Spokane Design Review Board

Wednesday, April 24, 2024

5:40 – 6:45	4) Spokane County Operations Complex – Recommendation Meeting	Dean Gunderson
	<ul style="list-style-type: none">• Staff Report Presentation• Applicant Presentation• Public Comments• Board Discussion

Since our last meeting the Spokane County Operations building has progressed significantly. Both the buildings and site have been developed to show materiality and character which you will see represented in the Design Review Board comment responses on the following pages.

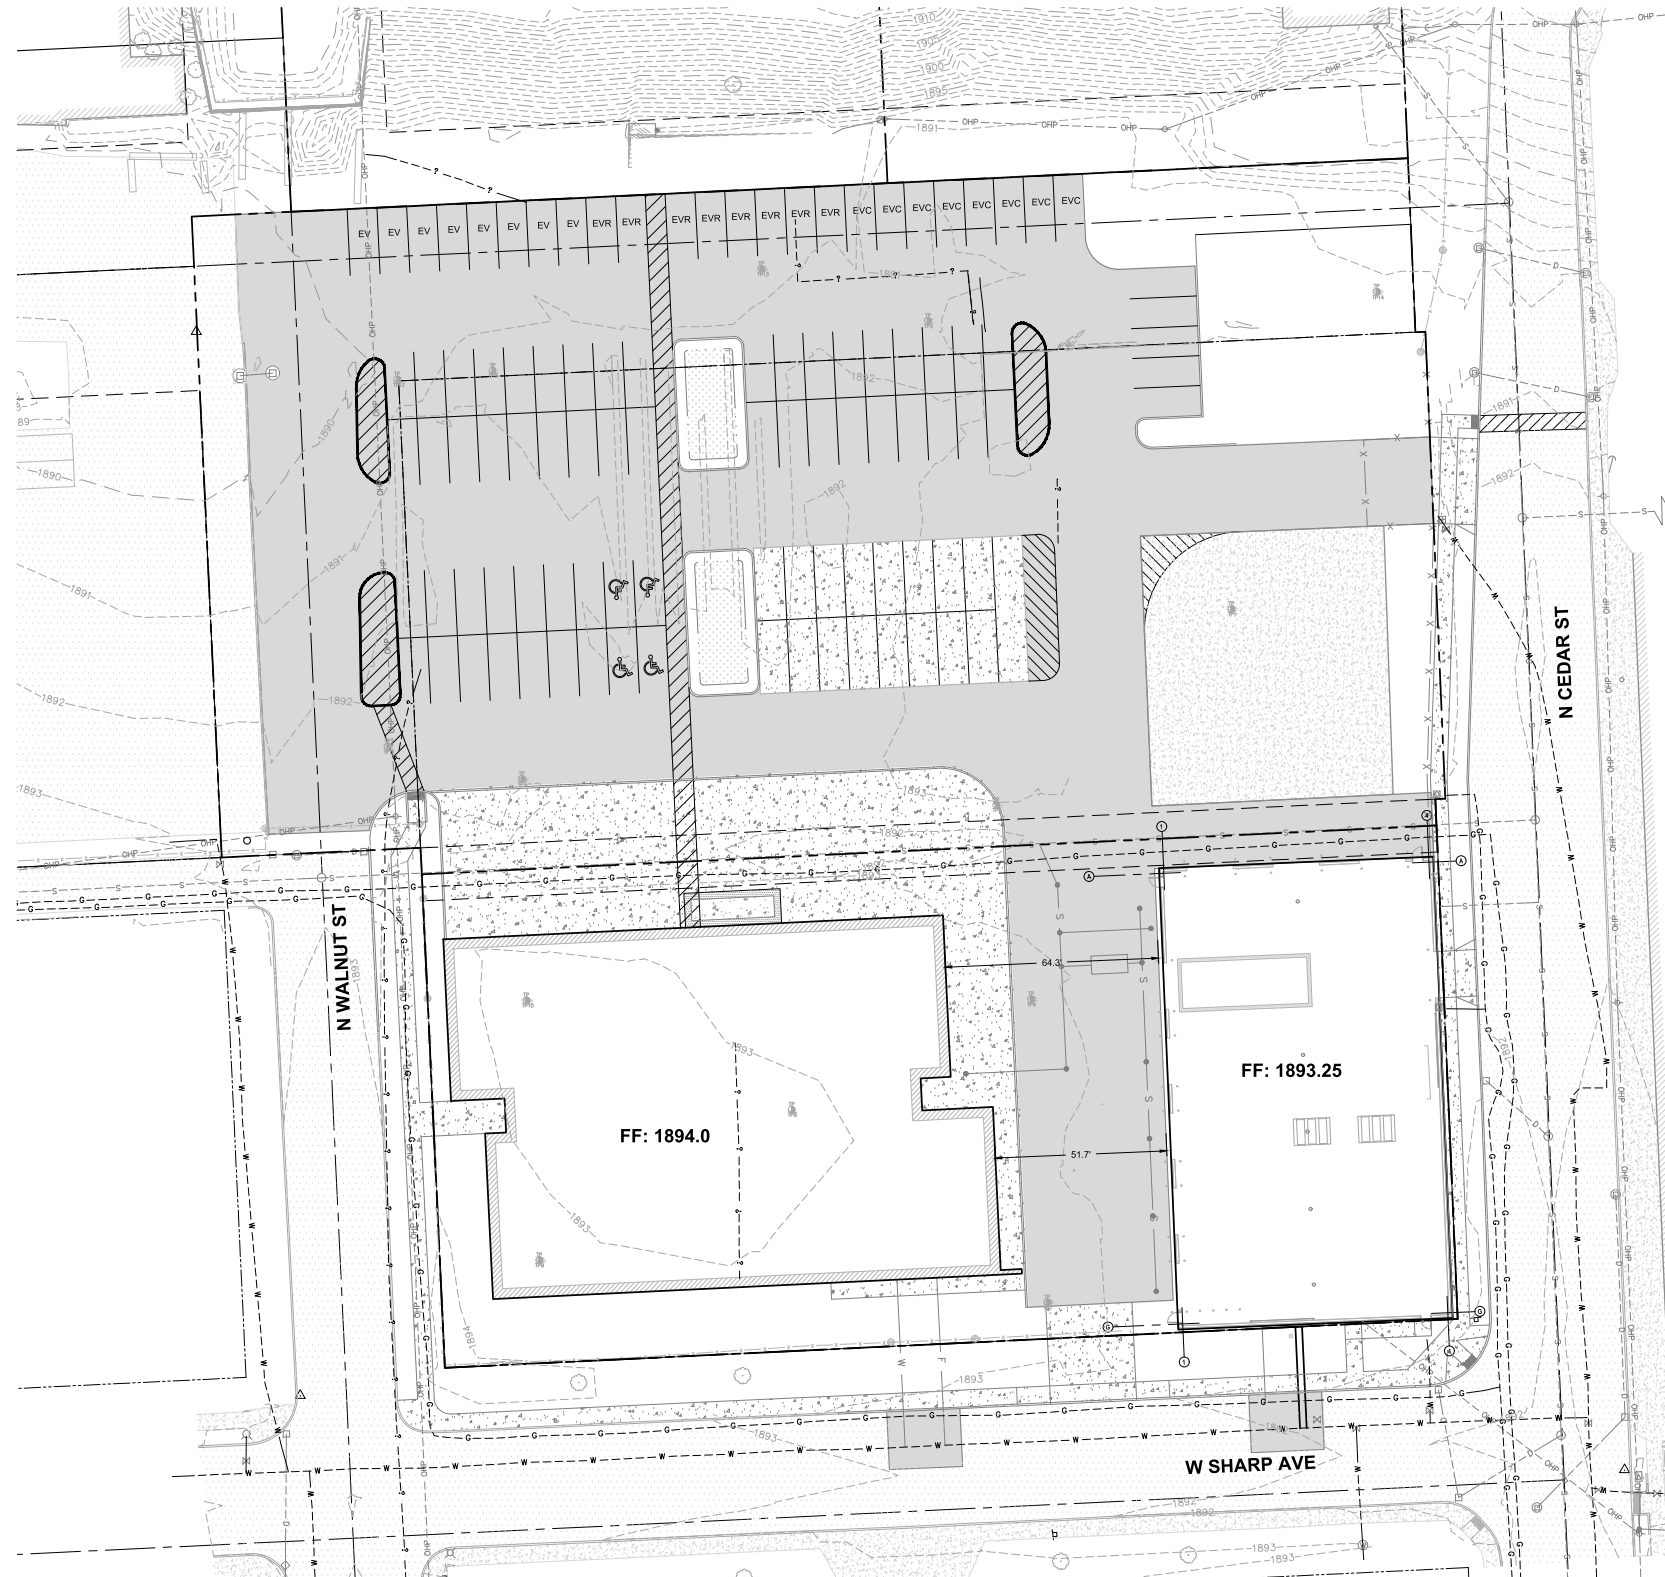
The applicant should consider installing the necessary curb-ramps for an unmarked pedestrian crossing north of the new curb cut for the Subject Site's drive access to the secure lot and south of the existing STA curb cut.

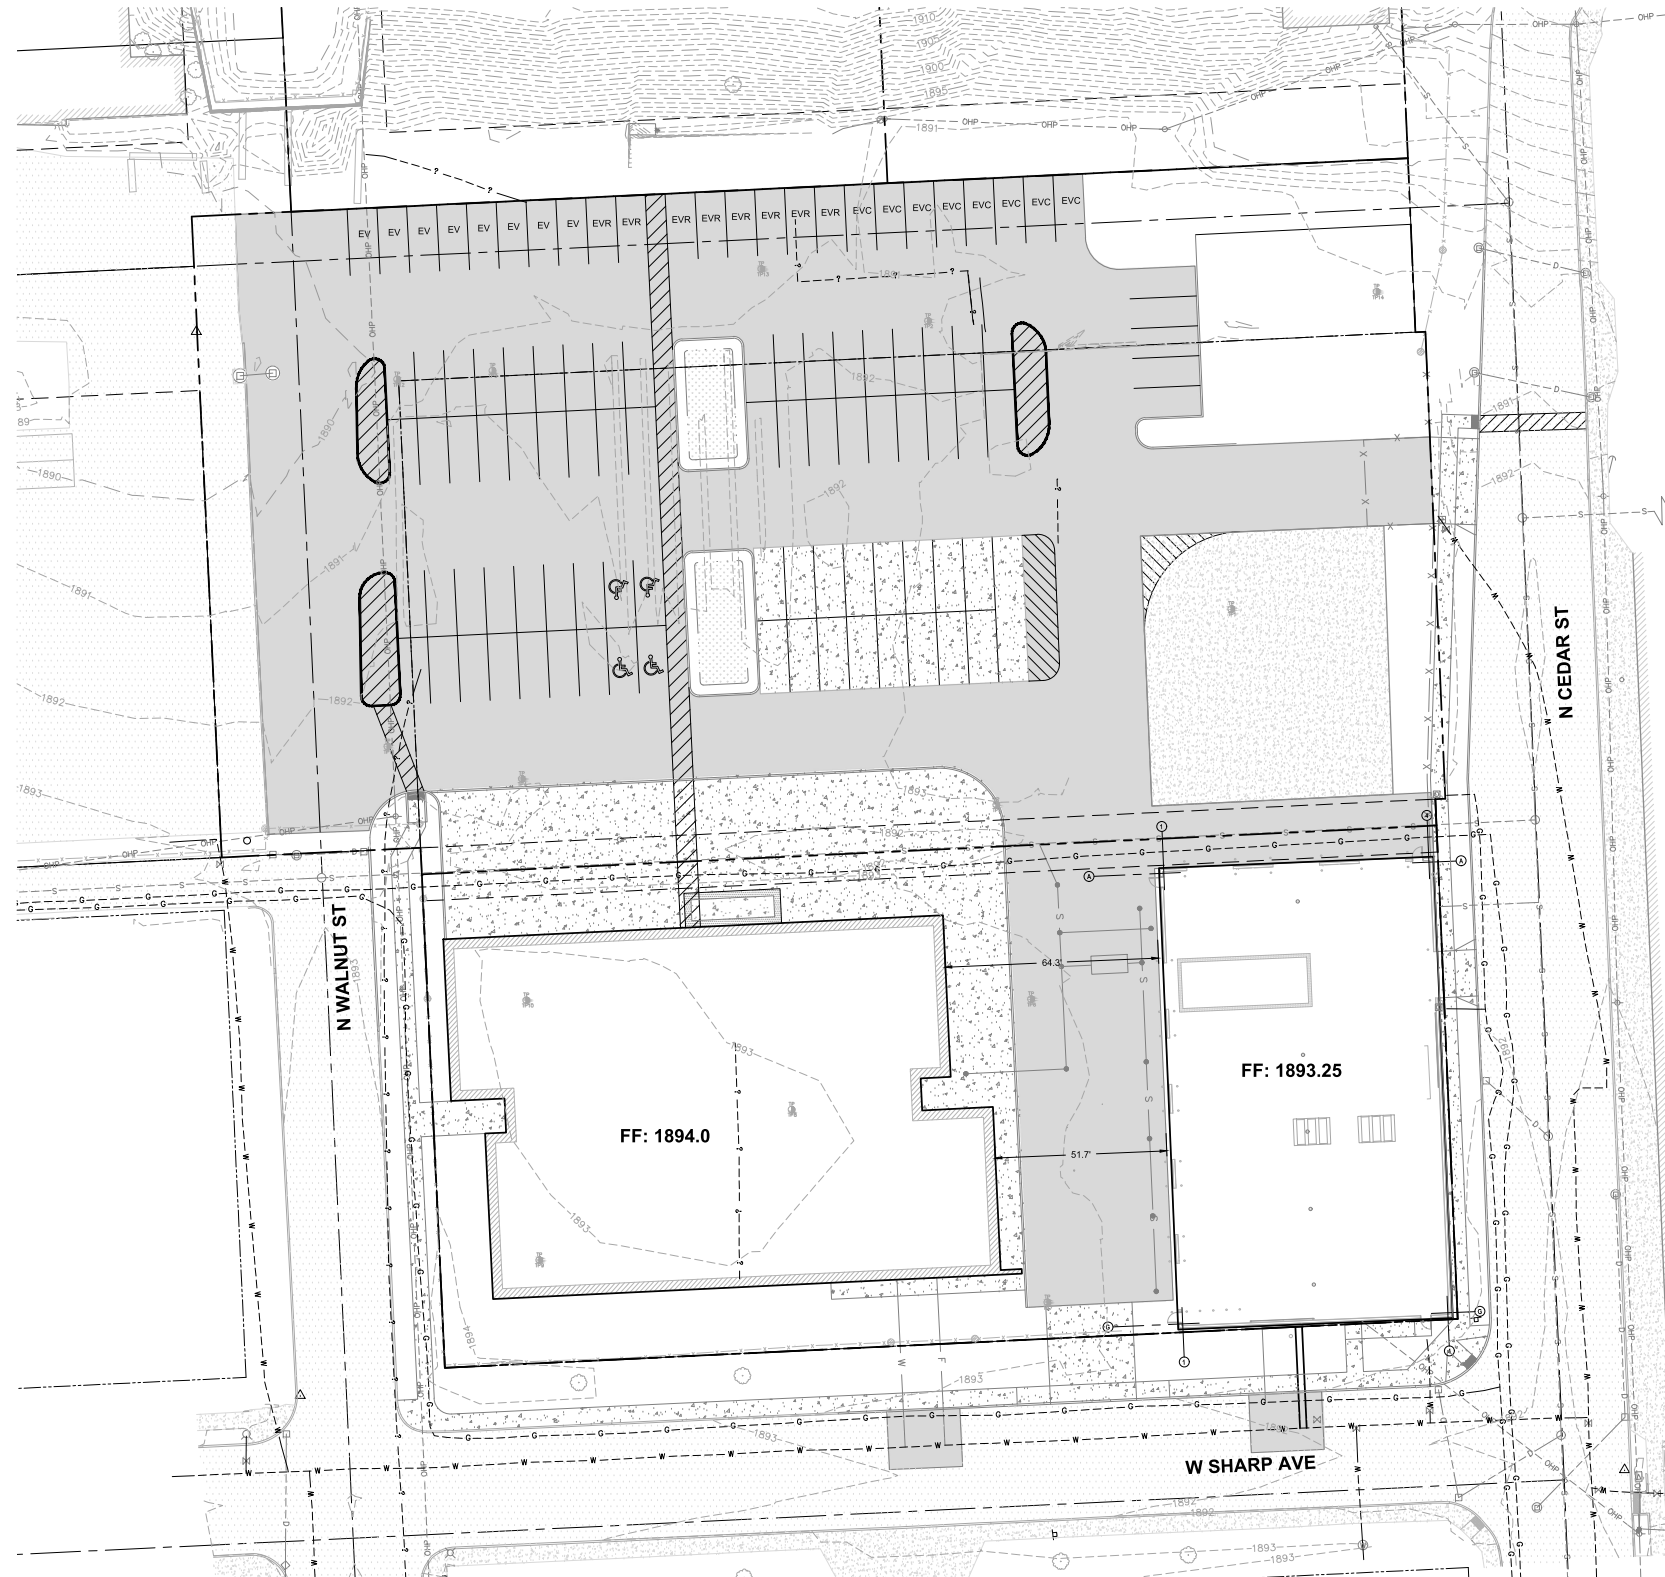
Support for elimination of sidewalk north of new crosswalk due to Sinto Ave. constraints. This will provide continuous pedestrian access along the Cedar/Sinto corridor.

Advisory Action 8

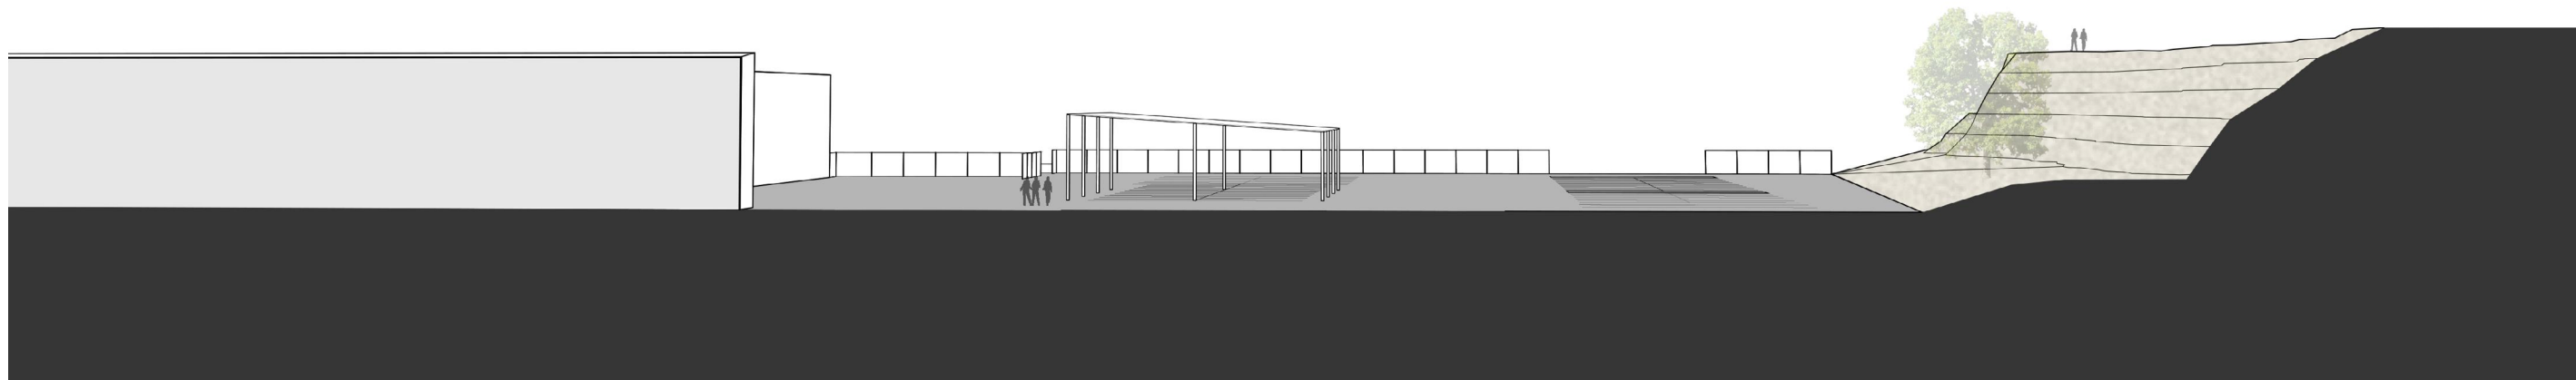
The Applicant is encouraged to consider the character of the buildings' façades and how they may enhance the immediate public realm through the use of material, color, texture, lighting, signage, art, etc.
